**From:** Facilities  
**Sent:** Monday, March 27, 2023 3:07 PM  
**To:** harold@alwayspavinginc.com; 'mike@vvexc.com'; ted@jbbostick.net; glenm@vintagepavingco.com  
**Subject:** Addendum No. 2 - Request for Quote for Maintenance Yard Asphalt Repair and Resurface

Travis Unified School District request a quote to repair and resurface four areas at our District Complex and Maintenance Yard, request number 23030. This solicitation will become an addendum to any resultant contract.

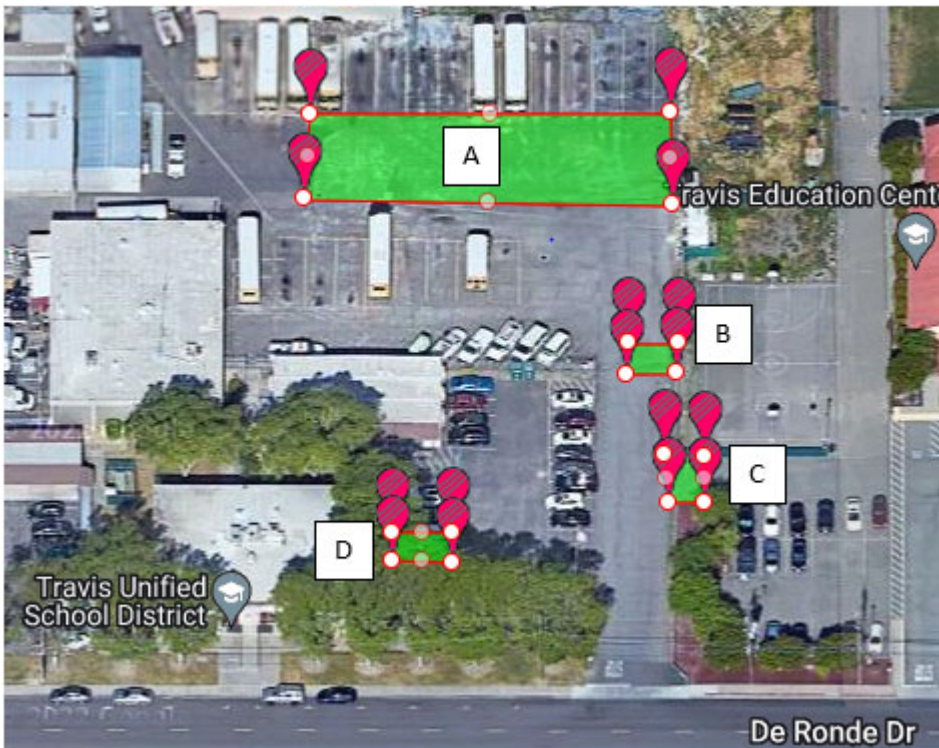
- Area A
  - Remove existing asphalt and associated aggregate base.
  - Place 4 ¾ ” of asphalt over 18” aggregate base compacted to 95% minimum, on subgrade.
  - Provide optional cost for installation of geo fabric.
  - Slope finish to existing drain.
- Area B
  - Remove approximately 300 sq. ft. of existing asphalt and associated aggregate base.
  - Place 4 ¾ ” of asphalt over 18” aggregate base compacted to 95% minimum, on subgrade.
  - Provide optional cost for installation of geo fabric.
  - Slope finish to existing drain.
- Area C
  - Grind 1.5” of approximately 300 sq. ft. and apply asphalt overlay to achieve slope toward existing drain.
- Area D
  - Remove approximately 300 sq. ft. of asphalt and associated aggregate base.
  - Place 2” of asphalt over 6” aggregate base and compacted to 92 % minimum, on subgrade.
  - Slope finish to existing drain.
